Second Revision No. 8472-NFPA 70-2021 [Global Comment]

Relocate requirements for feeders, outside branch circuits and feeders, and services over 1000 Vac or 1500 Vdc from Articles 215, 225, and 230 into the new Article 235. See attached word document for deletions from Articles 215, 225, and 230, and the new requirements to be added to Article 235.

Global SR-8472 [CMP-10]

Figure Informational Note Figure 230.1 Services.

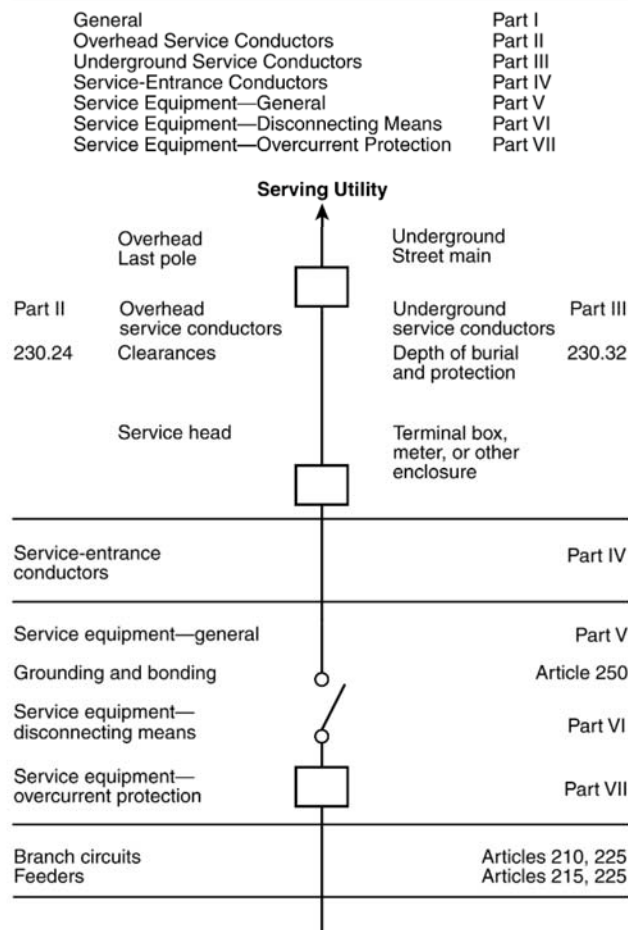
Informational Note No. 1: See Informational Note Figure 230.1.

Informational Note No. 2: See Part V of Article 235 for services over 1000 volts ac or 1500 volts dc, nominal.
